INSPECTORS REPORT ON A LICENCE APPLICATION

| RE: | Application for a Waste Licence from Roadstone Wood Ltd, Fortunestown, Tallaght, Dublin, 24. Licence Register W0269-01 | |

| Type of facility: | Inert Waste Recovery Facility |
| Location of facility: | Fassaroe Waste Recovery Facility, Fassaroe Avenue, Bray, Co. Wicklow. |

Figure 2: Facility Boundary and Layout

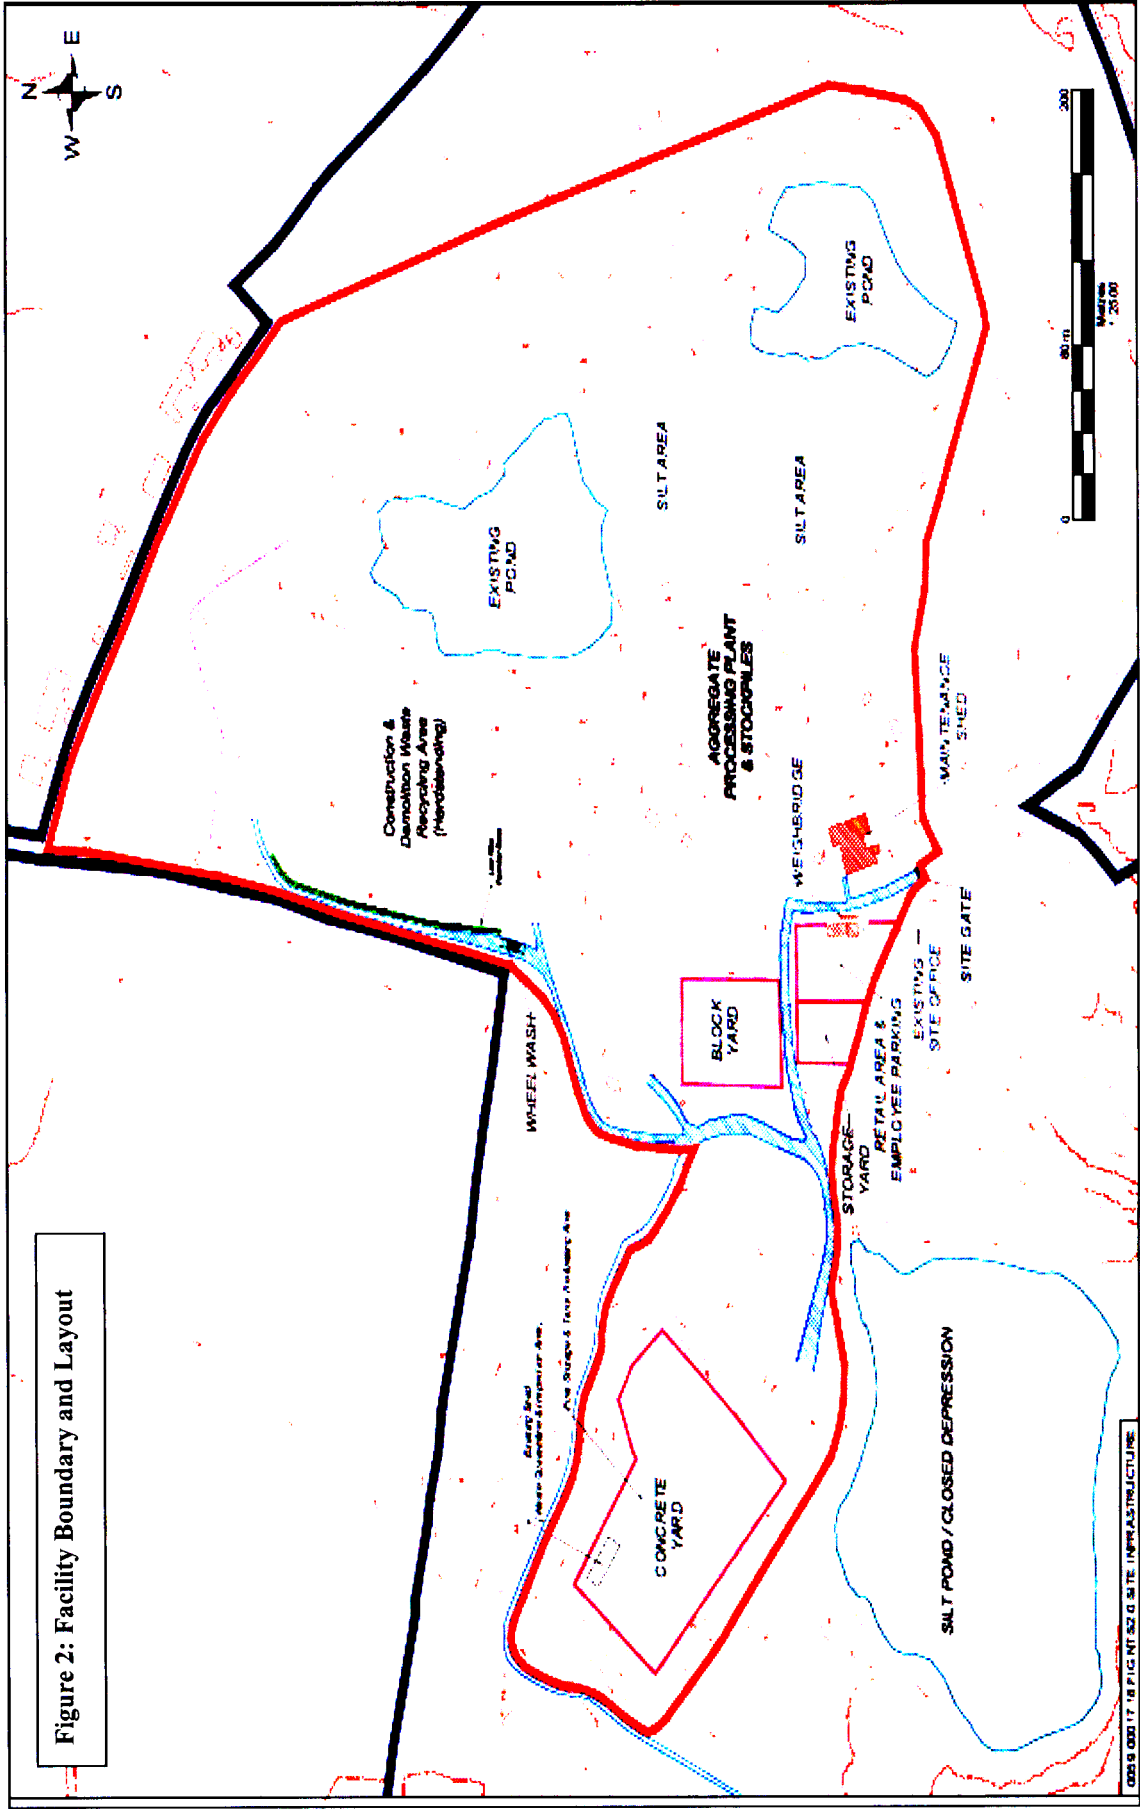
An existing large concrete-floored shed at the former concrete production yard, which is located at the western end of the site (see Figure 2 below), is proposed by the applicant as a location for the waste quarantine and inspection area. Suspect waste loads will be diverted to the waste quarantine area for closer examination pending removal off-site to a suitable waste disposal/recovery facility. **Condition 3.6** of the RD sets out the requirements with regard to the operation of the waste inspection and waste quarantine areas.
